Access Compliance Report Public Rights-of-Way (Curb Ramps)

Intersection ID: N/A Main Street: SUMMERFIELD RIDGE LN **Cross Street: MILL VALLEY CT** Location: ADA ID: 963DF228E042 Ramp Type: PerpDiag Initial Pass/Fail: Fail **Overall Compliance: No** Severity Score: 33.75

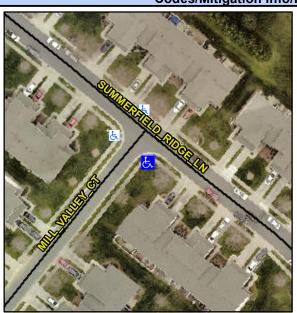
Street 1 Name Stop Condition-Street 2 Street 2 Name Stop Condition-Street 1 SUMMERFIELD RIDGE LN None **MILL VALLEY CT** StopSign Possible Solutions: Remove & Replace Curb Ramp With Two New Directional Ramps or Equivalent. Surveyor Notes: N/A PROW/ADA: R304.5.1, R304.2.2, R304.5.3

Field Measurements/Component Compliance							
	Compliance Description		Data	Compliance Description		Description	Data
	N/A	Ramp Length (in)	48.0	No	Ram	Slope (%)	8.6
	No	Ramp Width (in)	36.0	No	Ramp	XSlope (%)	6.5
	N/A	Flare Type LT	N/A	N/A	Flare	Type RT	N/A
	N/A	Flare Slope LT (%)	N/A	N/A	Flare	Slope RT (%)	N/A
	N/A	Flare Traversable LT?	No	N/A	Flare	Traversable RT?	No
	N/A	Landing Length (in)	N/A	N/A	DWS	Provided?	N/A
	N/A	Landing Width (in)	N/A	N/A	DWS	Contrast?	N/A
	N/A	Landing Slope (%)	N/A	N/A	DWS	Length (in)	N/A
	N/A	Landing X Slope (%)	N/A	N/A	DWS	Full Width?	N/A
	N/A	Landing Curb? (Y/N)	N/A	N/A	DWS	Offset (in)	N/A
	N/A	Shared Landing?	N/A				
	N/A	Gutter Ponding?	N/A	N/A	Gutte	er Slope (%)	N/A
	N/A	Gutter Lip Ht (in)	N/A	N/A	Gutte	er X Slope (%)	N/A
	N/A	Painted X Walk1?	No	N/A	Paint	ed X Walk2?	No
		X Walk 1 Direction	To NE		X Wa	lk 2 Direction	To NW
	N/A	X Walk 1 Width (in)	N/A	N/A	X Wa	lk 2 Width (in)	N/A

X Walk 1 Slope (%)	1.7		X Wa	lk 2 Slope (%)	2.5
		X Walk 1 X Slope (%)	1.4		X Wa	lk 2 X Slope (%)	4.1
	N/A	Ramp inside XWalk1?	N/A	N/A	Ram	o inside XWalk2?	N/A
		Road Slope (%)	3.3	N/A	Clear	Space?	N/A
		Road X Slope (%)	1.8	N/A	Clear	Space to XWalk (in)	N/A
	N/A	Any Obstructions?	N/A	N/A	Storn	n Grate/Utility Hazard?	N/A
		Obstruction Type			Storn	n Grate/Utility Type	
			N/A				N/A
				Yes	Surfa	ce Condition? (G/P)	Good
1
